09-022/14 - MULTI-MODEL - MULTIPLE ELECTRICAL MALFUNCTIONS AFTER BODY REPAIR

Subject: MULTIPLE ELECTRICAL MALFUNCTIONS AFTER BODY REPAIR	Bulletin No: 09-022/14
	Last Issued: 05/30/2014

- This bulletin supersedes the previous bulletin 09-022/14, issued on 05/20/14. The APPLICABLE MODEL(S)/VINS has been revised.
- Changes are noted below in Red beside the change bar.

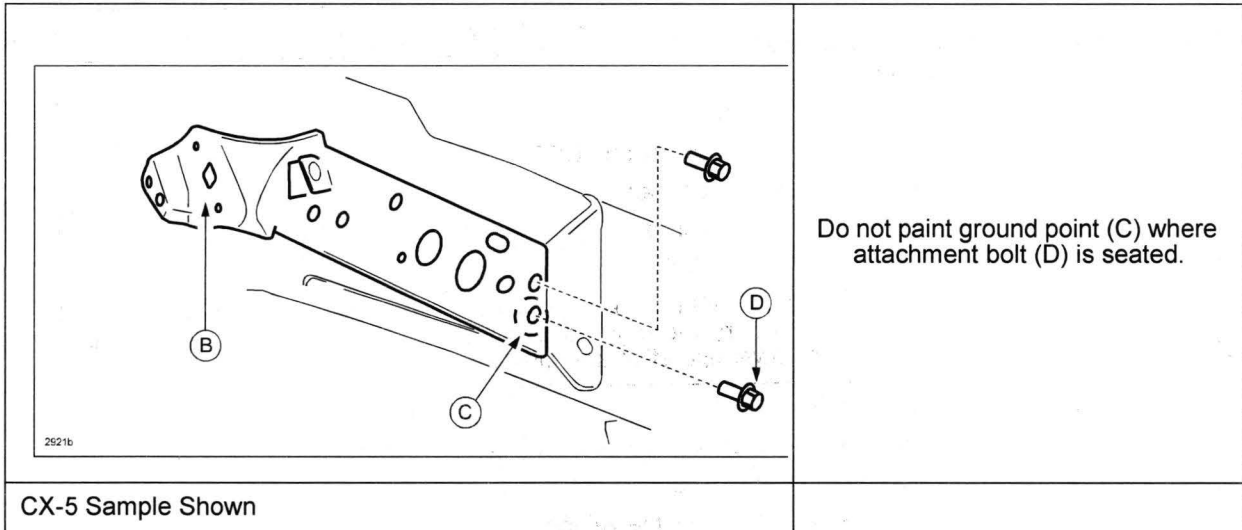
The front fender stay (B) newly painted surface at ground point (C), where attachment bolt (D) is seated, may create a poor front harness ground connection.

Customers concern can be resolved by sanding off paint at ground point (C) where attachment bolt (D) is seated. After installing the bolt (D), apply touch-up paint to the exposed base material area of the front fender stay.

NEWLY INSTALLED FRONT FENDER STAY NOTE

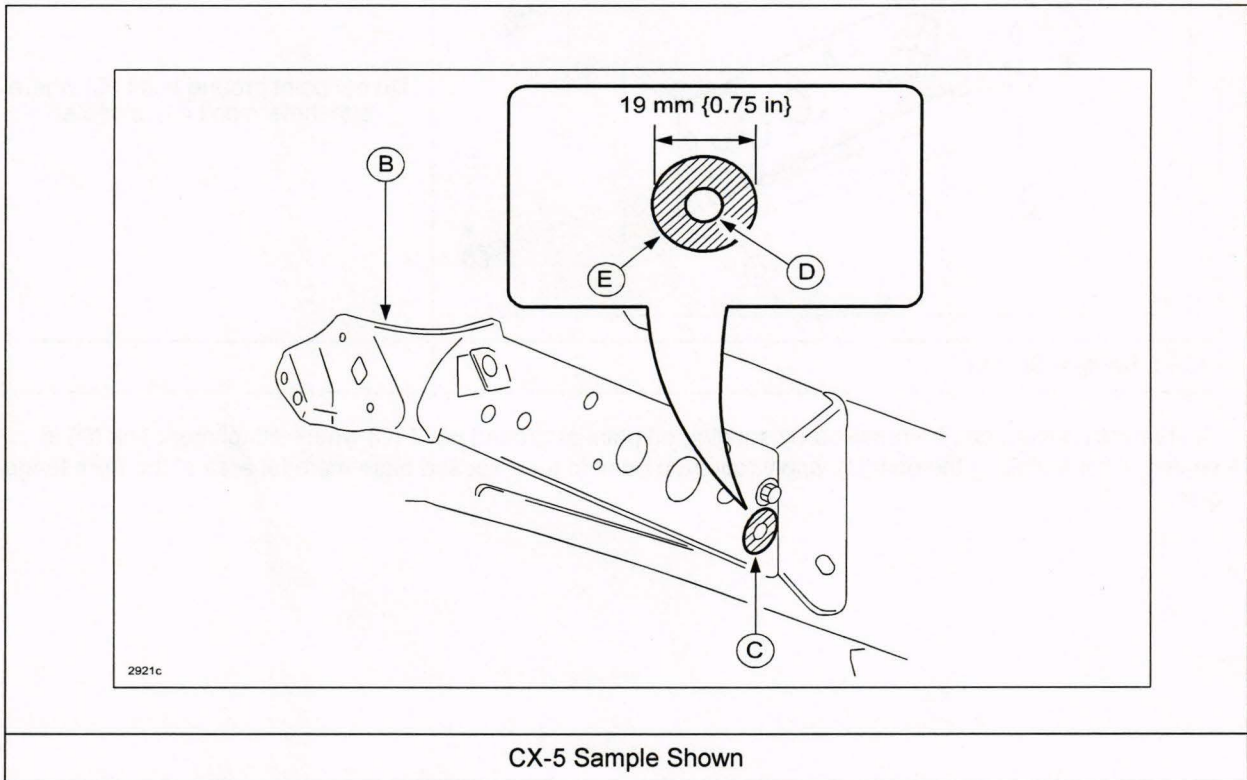
CAUTION: If the bolt (D) contact area (C) is painted when the front fender stay (B) is newly replaced, it could cause a malfunction in the PCM. Before painting a newly replaced part, protect the bolt (D) contact area (C) with masking tape (E) as shown in the figure.

NOTE: After installing the bolt (D), apply touch-up paint to the exposed base material area of the front fender stay.
